**DOS RIOS WRC THICKENING FACILITY EXPANSION PROJECT**

**Solicitation Number: CO-00168**

**ADDENDUM 3**

**Date April 2, 2018**

SHEET **I-06**  
 9 OF 96

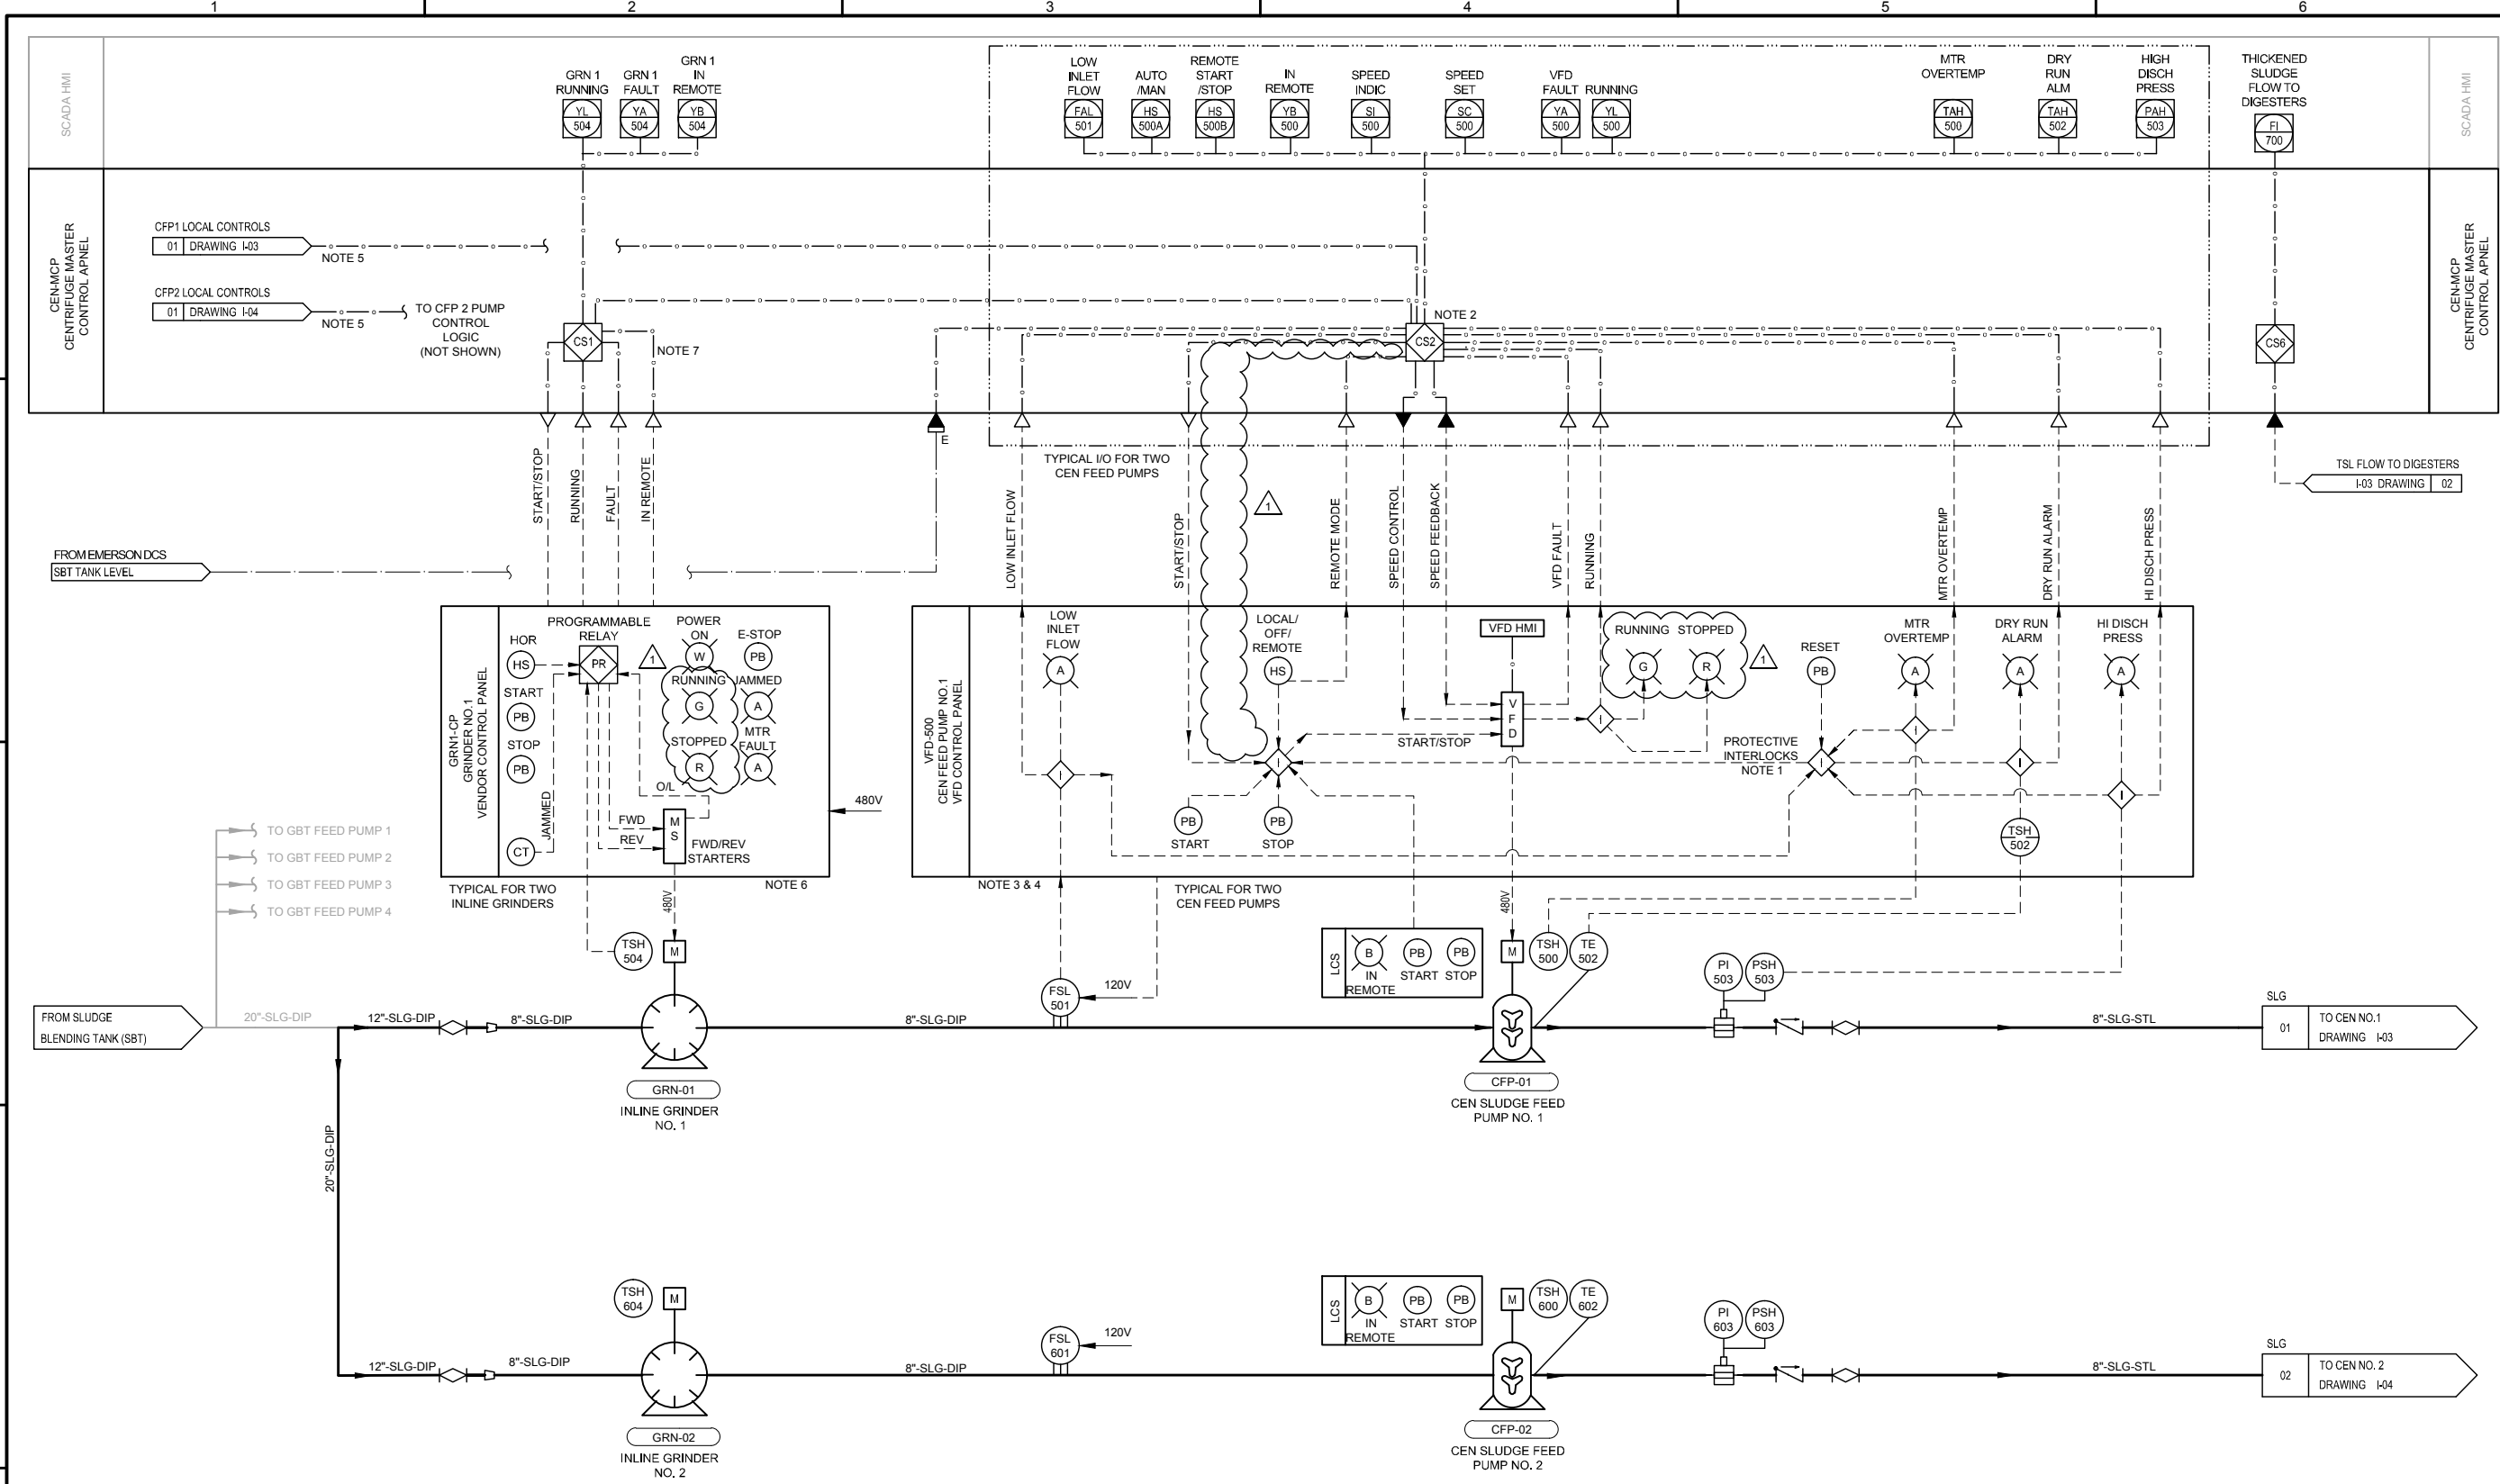
1. Sheet E-03, Replace the sheet with the attached.
  - a. Update to light fixture schedule.
2. Sheet E-21, Replace the sheet with the attached.
  - a. Relocating of light fixtures around centrifuge.
3. Sheet EZ-02, Replace the sheet with the attached.
  - a. Equipment pad slab detail updated.
4. Sheet M-13, Replace the sheet with the attached.
  - a. Detail 3 updated to change double pipe support design to not require footing.
5. Sheet S-03, Replace the sheet with the attached.
  - a. Removed detail 2.
6. Sheet I-02, Replace the sheet with the attached.
  - a. Changed running light colors.
7. Sheet I-06, Replace the sheet with the attached.
  - a. Changed running light colors.
